UNITED STATES PATENT AND TRADEMARK OFFICE

APPLICATION NO.	FILING DATE	FIRST NAMED INVENTOR	ATTORNEY DOCKET NO.	CONFIRMATION NO.
10/634,235	08/05/2003	Peter Bernhardt	1-24671	6403

Office Action Summary

DETAILED ACTION

Fig. 2

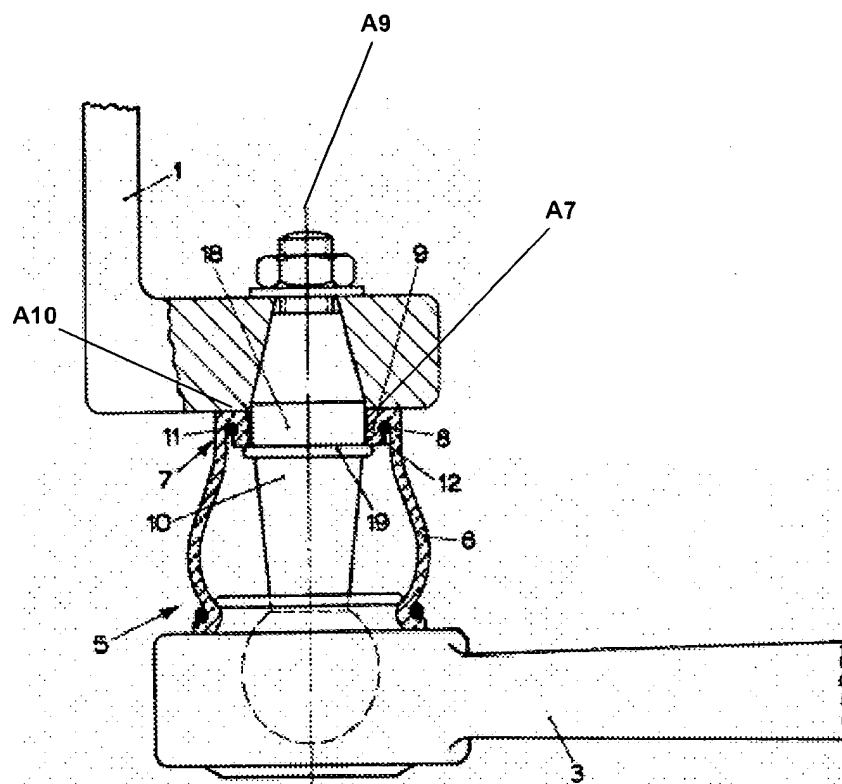
Claims 1-5 are rejected under 35 U.S.C. 102(b) as being anticipated by the German patent, DE-1,575,708 (see marked-up attachment).

Regarding claim 1, the German patent '708 discloses, in Figure 2, an assembly consisting of a vehicle component **1** and a ball joint **5**. The ball joint **5** includes a housing **3**, a ball stud **10**, and a sealing bellows **6**. The sealing bellows **6** lies against the housing **3** and the ball stud **10**. The ball stud **10** has a holding surface **18** and a shoulder **19**. The holding surface **18** lies against a sealing surface **A7** of the sealing bellows **6**. The ball joint **5** is mounted to the vehicle component **1** such that the sealing surface **A7** is compressed in an axial direction **A9** between the shoulder **19** and the vehicle component **1**. Applicant is reminded that limited patentable weight is given to the dimension of the sealing surface of the sealing bellows before being deformed. Since there is a shoulder 19, it is inherent that when the ball pivot is mounted, the sealing bellows does not move further beyond the shoulder 9 when being compressed.

Regarding claim 2, the holding surface **18** and sealing surface **A7** are cylindrical. Note, the sealing surface **A7** conforms to the holding surface **18** which is cylindrical.

Regarding claim 3, a contact surface **A10** is provided so as to adjoin the holding surface **18** on a side of the holding surface **18** facing away from the housing **3**.

Regarding claim 4, the sealing bellows **6** is provided with a metal ring **8** urging the sealing surface **A7** against the holding surface **18**.

Regarding claim 5, the sealing bellows **6** is dimensioned such the sealing bellows **6** cannot slip off from the holding surface **18** when the ball joint **5** is not mounted to the vehicle component **1**. Applicant is reminded that limited weight is given to features or characteristics of the parts of the invention prior to being an assembly. Since the invention is an assembly, all features and characteristics of the parts in the assembly should be in reference after assembling.

REPLACEMENT SHEET

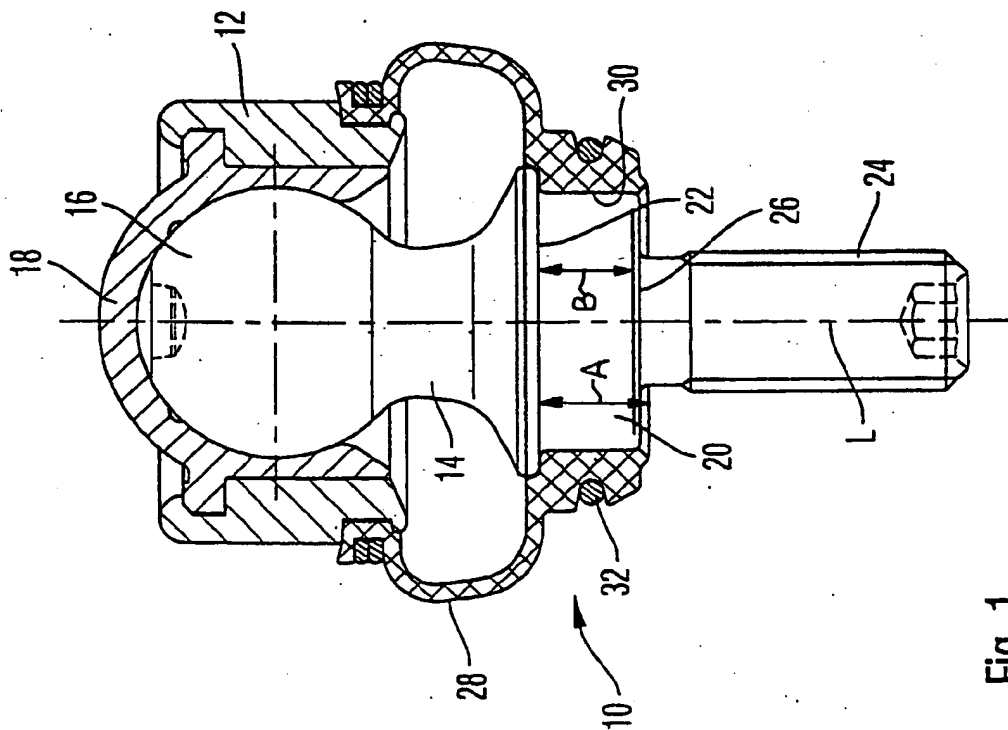
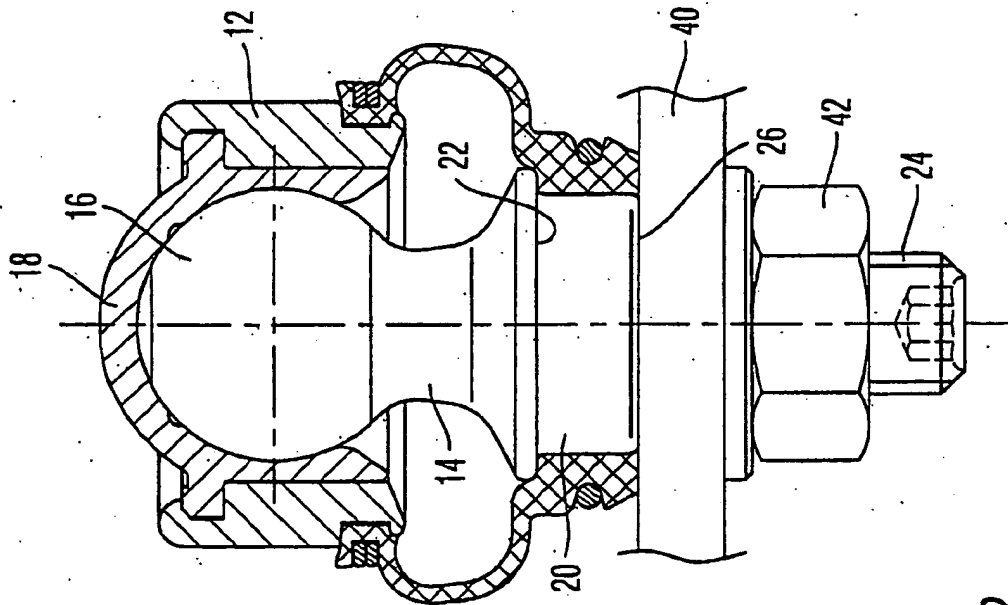
The drawings are objected to under 37 CFR 1.83(a) because they fail to show the height B measured between the plate (*vis.* plane) at which it contacts the shoulder 2 and its outer end as amended in the paragraph beginning on page 3, line 10 as described in the specification. Any structural detail that is essential for a proper understanding of the disclosed invention should be shown in the drawing. MPEP § 608.02(d). Applicant should note that the height B as presented in the replacement drawings is between the plane at which it contacts the shoulder and some extra line, which is not the outer end of the shoulder 20.

The drawings are objected to because the line unreferenced in Figures 1 and 2 above the outer end of the shoulder 20 makes unclear what it represents. The extra line appears to be a draftsman's error and needs to be deleted. Further, the cross

hatching of the sealing bellows 28 is incorrect. Corrected drawing sheets in compliance with 37 CFR 1.121(d) are required in reply to the Office action to avoid abandonment of the application. See MPEP 608.02(e).
